BOARD OF ADJUSTMENT
BOONE COUNTY PLANNING COMMISSION

STAFF REPORT **#1**

The applicant has applied for a Variance to increase the sign area of the Florence Square architectural freestanding sign located near the Mall Road right-of-way line. The proposal is to increase the sign area from 396.08 square feet to approximately 1,075 square feet.

OVERALL QUARE FOOTAGE
(FULL HEIGHT AND WIDTH)
1075

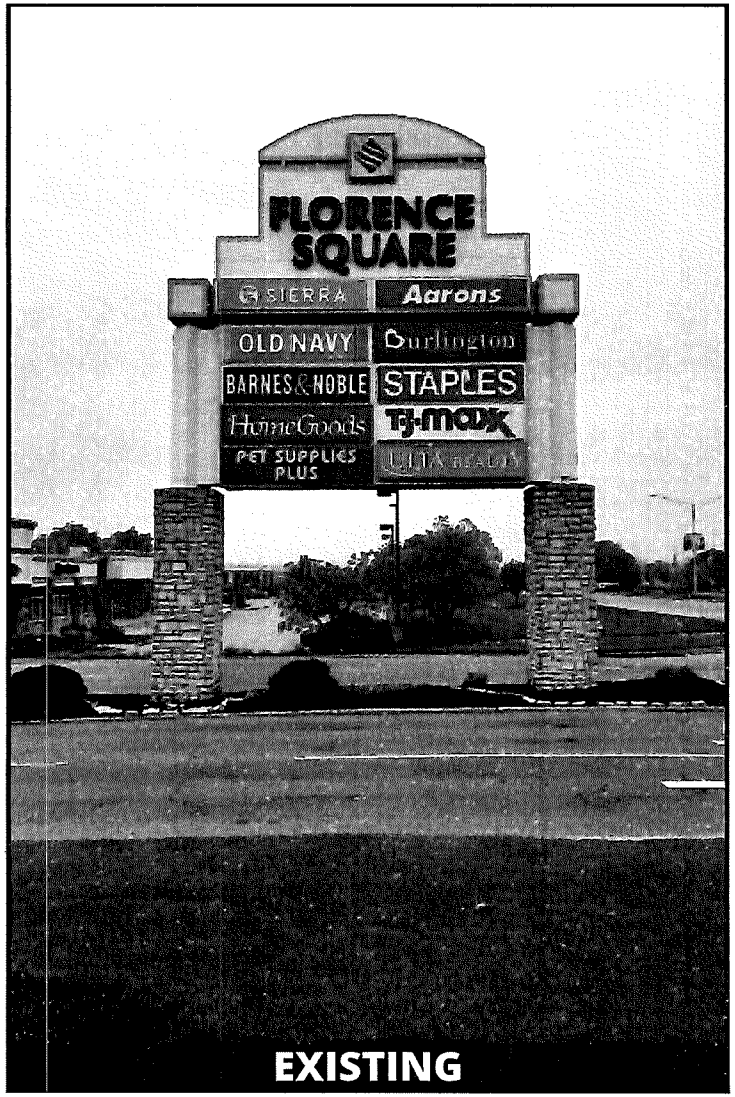
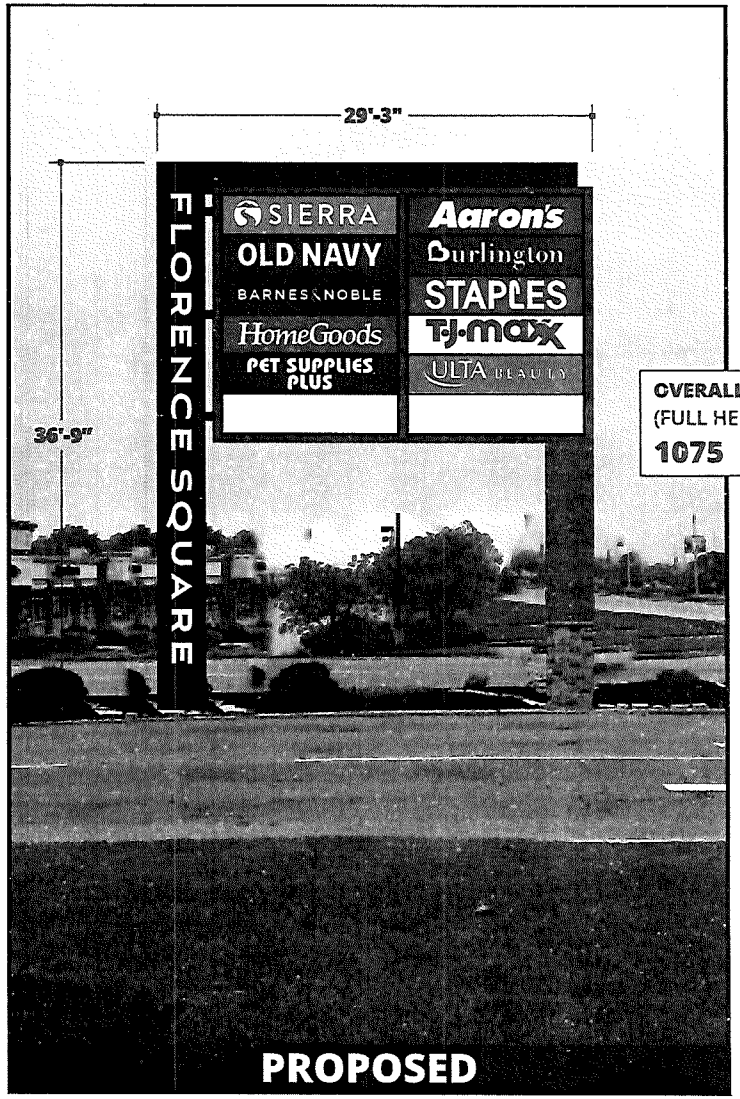
The only proposed change to the sign is adding "Florence Square" on one of the pillars (legs) of the sign. The "Florence Square" channel letter sign measures 16" x 378" (42 square feet) and would be constructed with white LED modules and acrylic faces. The sign code requires the sign area to be computed by drawing one rectangle around all advertisement.

B. On 2/16/24, Boone County Planning Commission issued a Sign Permit which allowed the existing architectural freestanding sign to be modified. The permit was approved because the height and area of the sign were being decreased.

- The sign shall be constructed as presented. Any proposed modification to the sign which includes adding height, sign cabinets, or additional advertisement shall be reviewed through an appropriate public hearing process.

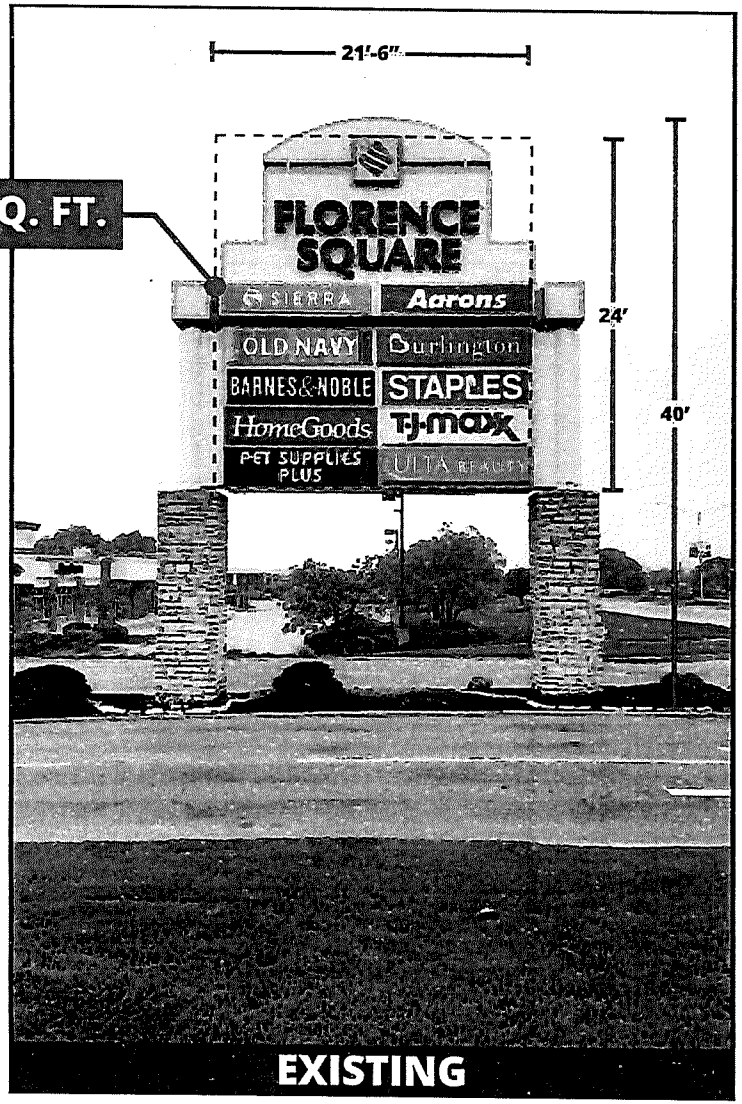
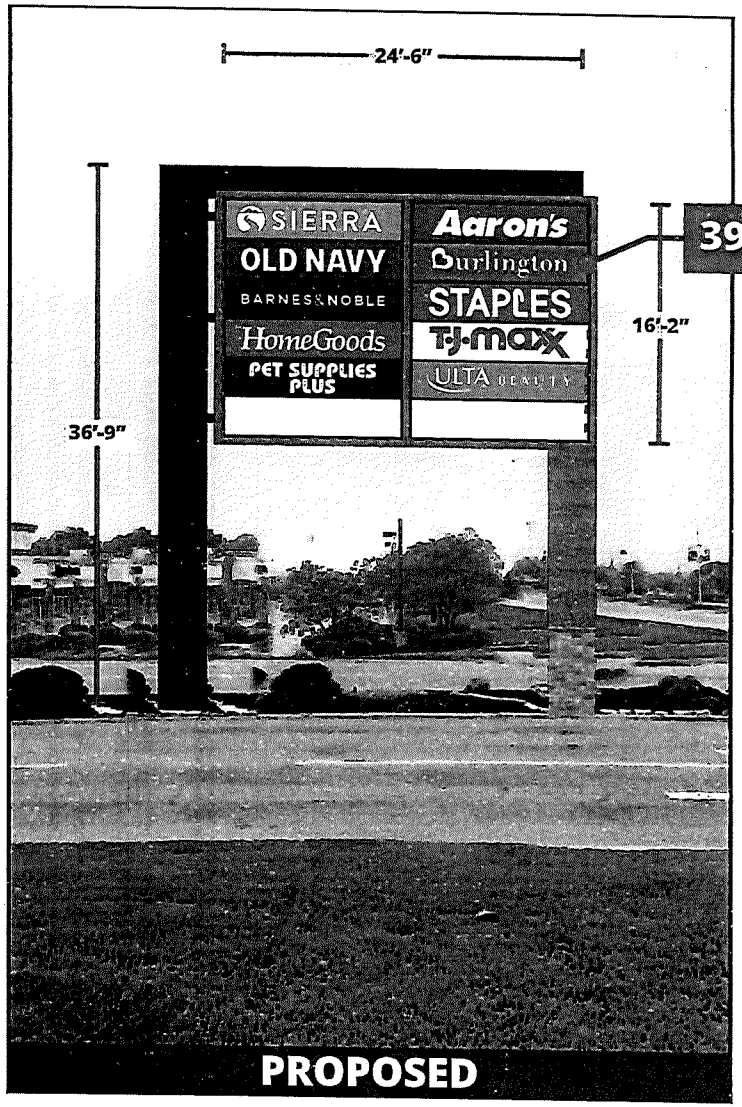
A. On February 16, 2024, Boone County Planning Commission approved Sign Permit application allowing the non-conforming, subdivision freestanding sign to be modified. The permit shows the existing sign was 40' tall and 516 square feet in area and the proposed sign was 36'-9" tall and 396.08 square feet in area.

- Allow the non-conforming, subdivision freestanding sign to be modified. The existing sign is 40' tall and 516 square feet in area. The modified sign will be 36'-9" tall and 396.08 square feet in area.
